State of New Mexico
Energy, Minerals and Natural Resources Department

New Mexico Oil Conservation Division approval and conditions listed below are made in accordance with OCD Rule 19.15.7.11 and are in addition to the actions approved by BLM on the following 3160-4 or 3160-5 form.

API WELL #	Well Name	Well #	Operator Name	Type	Stat	County	Surf. Owner	UL	Sec	Twp	N/S	Rng	W/E
30-045-13030-00-00	HUERFANO UNIT	137	HILCORP ENERGY COMPANY	G	A	San Juan	F	J	31	26	N	9	W

Hilcorp Energy Company plans to recompleate the subject well in the Pictured Cliffs formation and downhole commingle with the existing Dakota. Attached is the PC C102, recompleate procedure & wellbore schematic. The DHC application will be submitted and approved prior to commingling. A Closed Loop system will be utilized.

Current Schematic

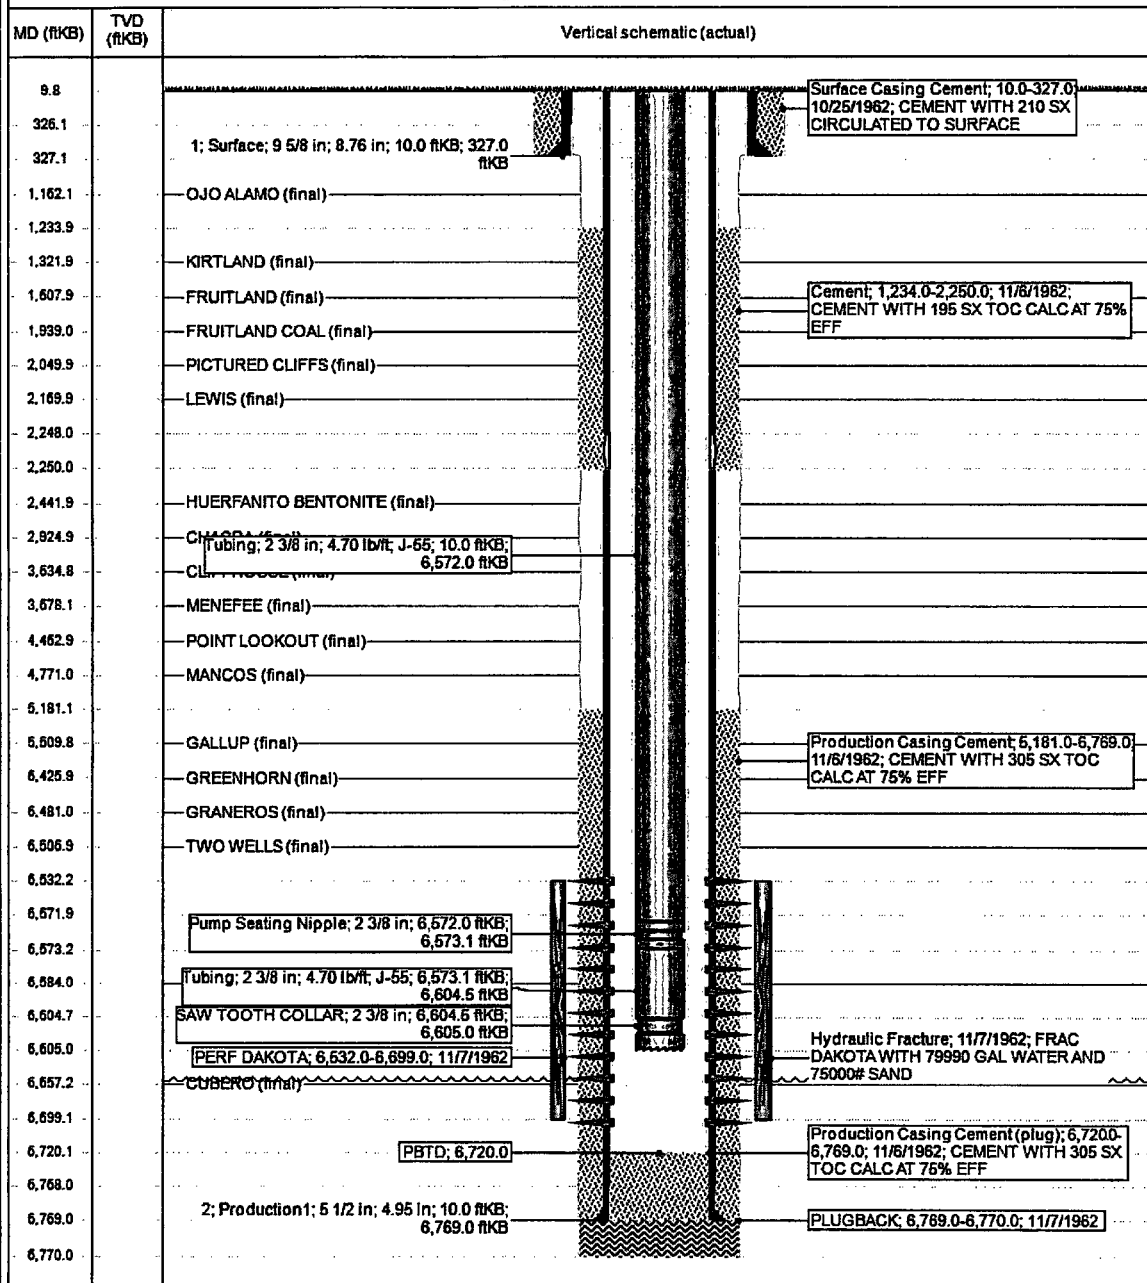
- Notify NMOCD 24hrs prior to beginning operations.
- Set cast iron bridge plug (CIBP) inside of cemented casing and at least 500' below the bottom of the proposed perforations. To show adequate formation/cement isolation.
- Perform and submit a cement bond log (CBL) to the agencies for review and approval prior to perforating the formation.
- If needed, submit proposed remediation to the agencies for review and approval prior to starting remediation.
- Hold C-104 for DHC.
